S E R V I C E N O T E

16700A Logic Analysis System Mainframe

Mainframe System RAM and Video RAM is Upgradable

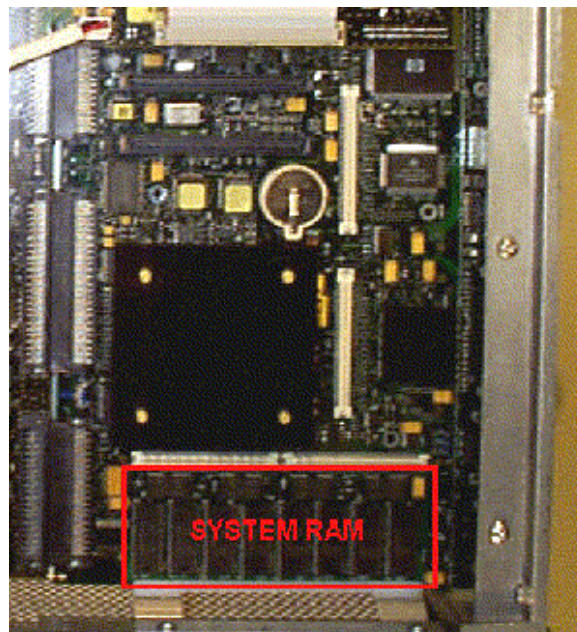
1. The service center orders the 128 MB System RAM Daughter Card and the Video RAM Module from GSL.
2. Using the procedures in the service manual, remove the top cover from the 16700A mainframe.
3. Remove the 32MB daughter card from the daughter card connector pair J4/J10 on the CPU board.

4. Install the 128MB memory daughter card into the daughter card connector pair J4/J10 on the CPU board, Ensure the daughter card also properly engages the nylon standoffs.

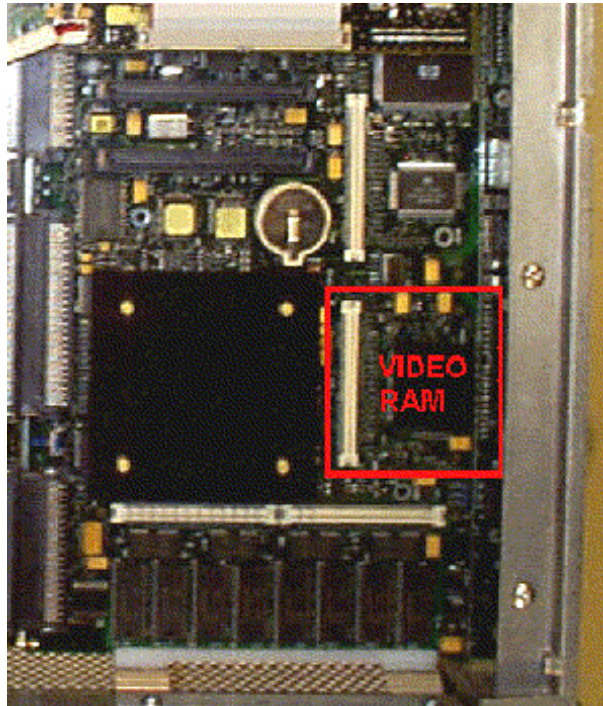
1 Locate the Video RAM Module connector J11 on the CPU board.

2. Install the Video RAM Module into the Video RAM Module connector J11 on the CPU board. Ensure the daughter card also properly engages the nylon standoffs.
